LIGO PROJECT

FACSIMILE COVER SHEET

1. Suggested Qualification Test and Coupon Test P & I schematic modification, per our telecon with Eric Brogren yesterday.
2. Suggested PDR meeting format, for our discussion. Please call me or Gerry (395-2905) when you receive this.

P & I DIAGRAM
VACUUM SYSTEMS
QUALIFICATION TEST
LIGO PROJECT
CALTECH

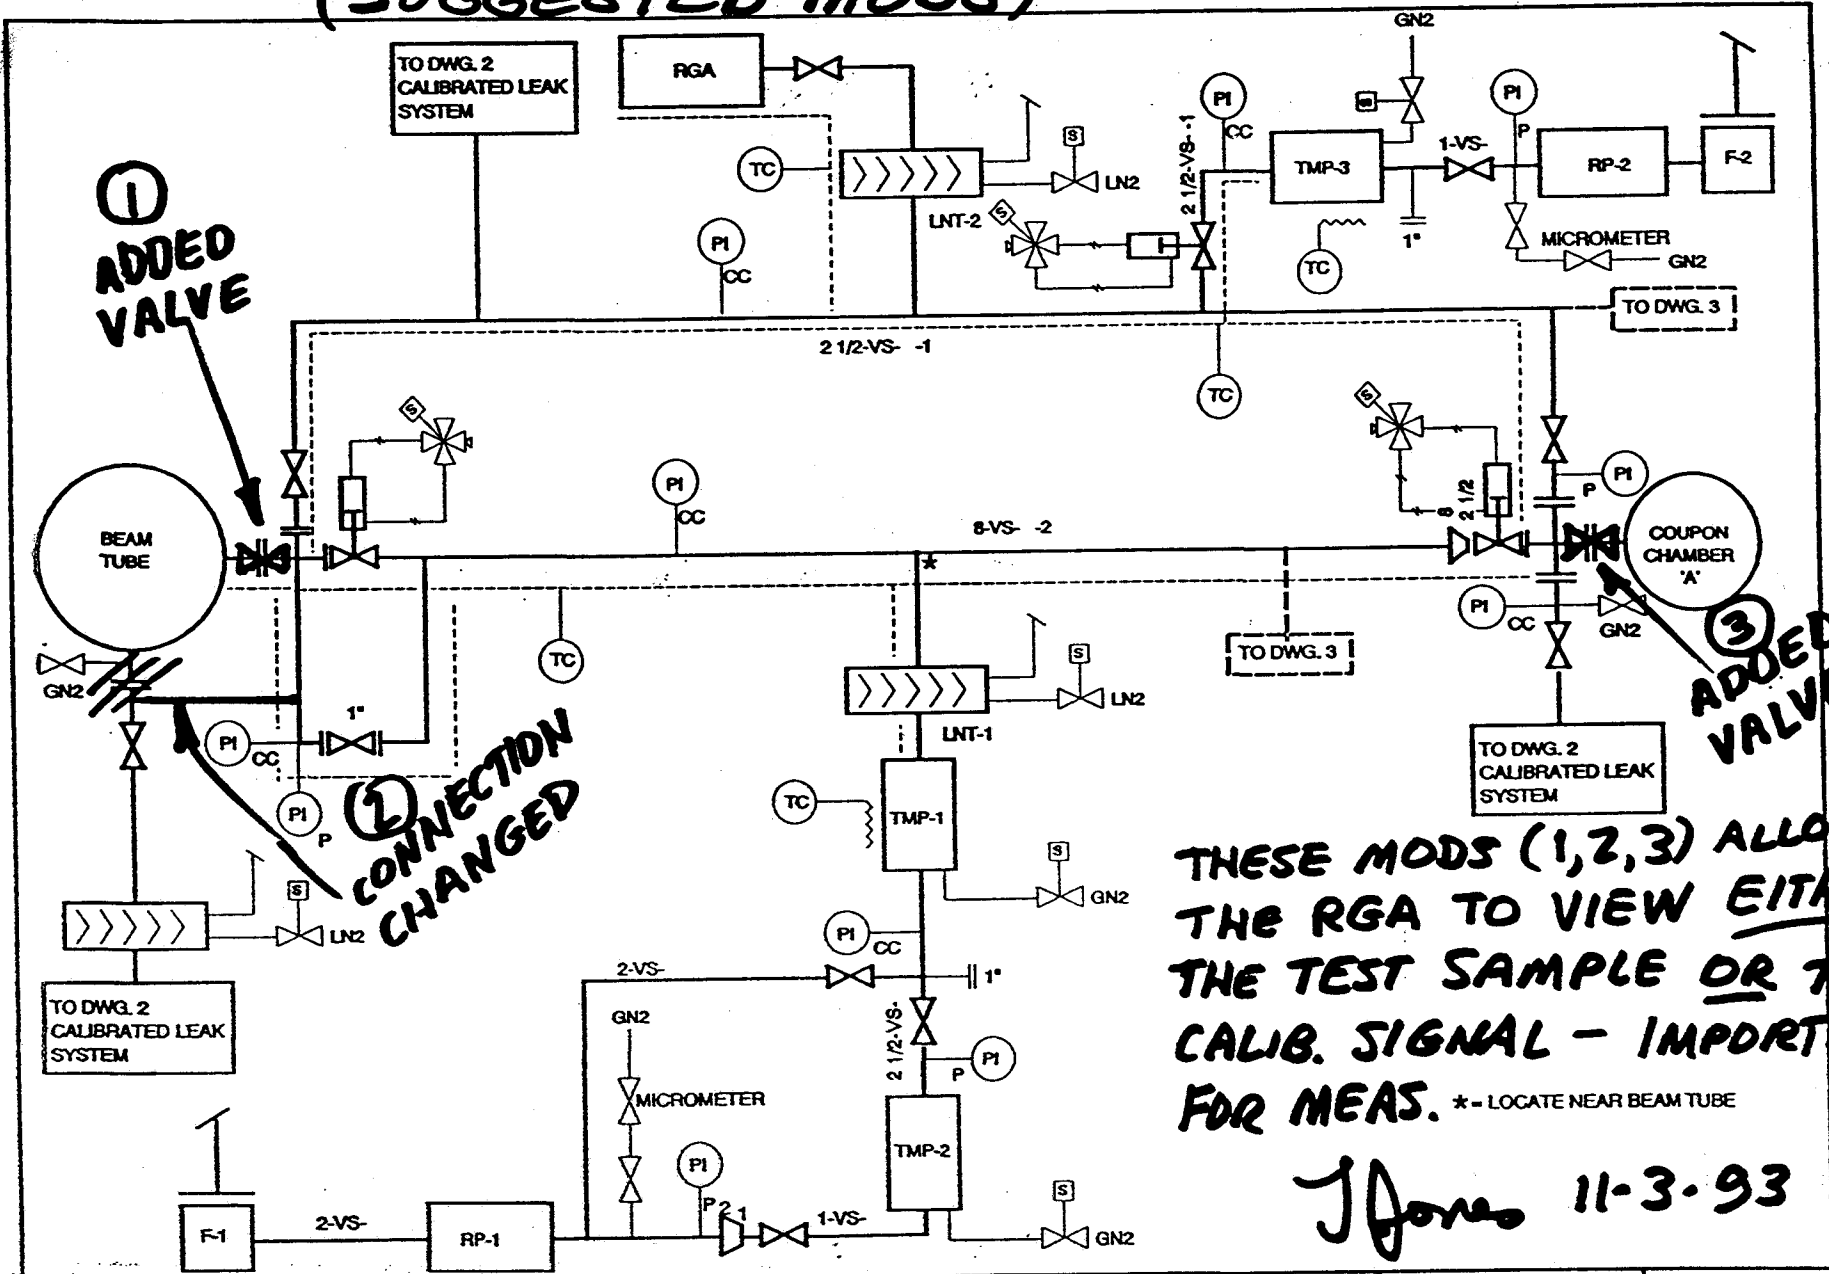
(SUGGESTED MODS)

THESE MODS (1,2,3) ALLOW THE RGA TO VIEW EITHER THE TEST SAMPLE OR THE CALIB. SIGNAL - IMPORTANT FOR MEAS. * - LOCATE NEAR BEAM TUBE
